Government Telegraph Department.
From,

No. 484 Madras dated 18 April 1896.

With reference to the Correspondence ending with your letter No. 195 C. dated the 18th of January 1896, I have the honor to inform you that in March last I inspected the new quarters and out offices which are in course of erection in the Compound of the Telegraph Office at Pambam, and which are being built for this Department to replace the quarters and out offices demolished to make room for the new Post office, and that I observed the following serious defects:-

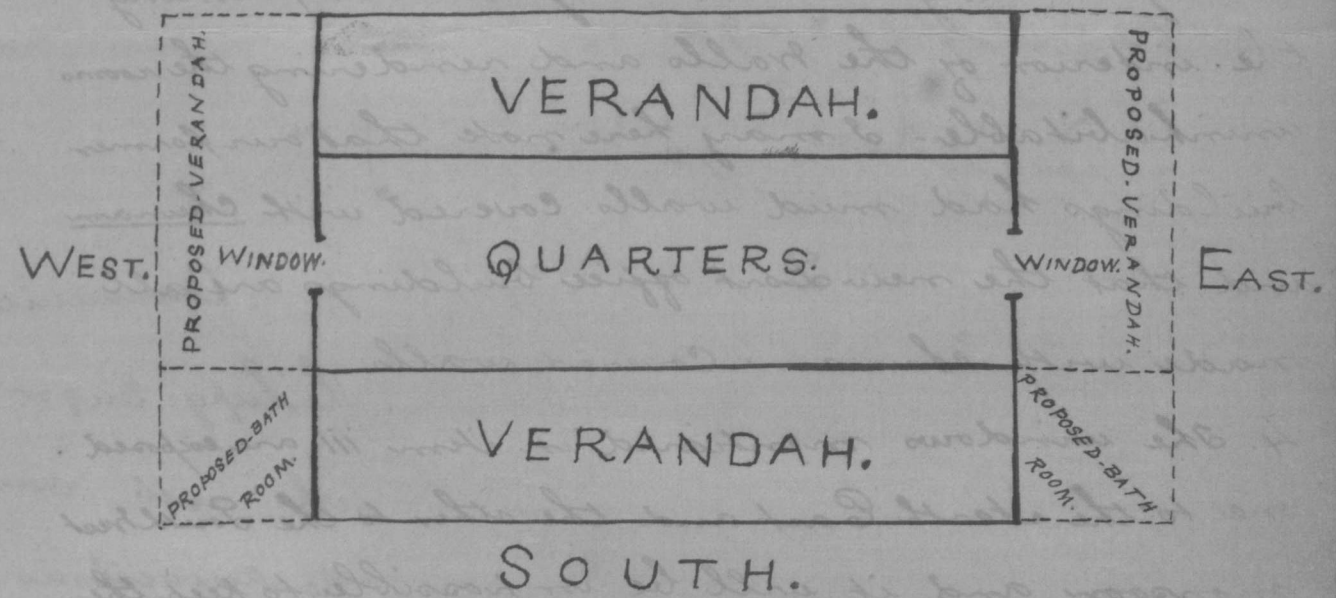
- i There are no bathrooms attached to the quarters,
- ii The walls of the quarters and of the out offices are plastered with mud which has been given a coating of whitewash,
- iii A window at each end of the quarters is totally unprotected from rain.

2. As regards the first item I need only say that the quarters which have been demolished were provided with two bathrooms both of which were required for use, and that they are equally necessary in the new quarters

3. Item ii is most important of all. In a station like Pamban, where the rain fall is heavy for many months of the year, - both the North-East and South-West monsoons visiting the place, - I look upon a whitewashed mud wall as practically useless, for the mud would soon be washed away leaving nothing but the rough stones forming the interior of the walls and rendering the rooms uninhabitable. I may here note that our former buildings had mud walls covered with Chunam and that the new Post office buildings are all made with Chunam covered walls.

4. The windows mentioned in item iii are exposed one to the North East and the other to the South West monsoon, and it will be impossible to keep the rain from beating in. Each window is only provided with a wooden shutter so that for a considerable period every year they will be of no use either for light or air.

6. My suggestions were that all the walls should be plastered with Chunam and that

South sides of the quarters should be continued all round them, two corners on the South side being walled in to provide bathrooms.

This latter suggestion is perhaps made clearer by the diagram below:-

Communicated to
the Supg. Engr. VI circle
who will carry out
the suggestions of the
Supt. of Telegraphs
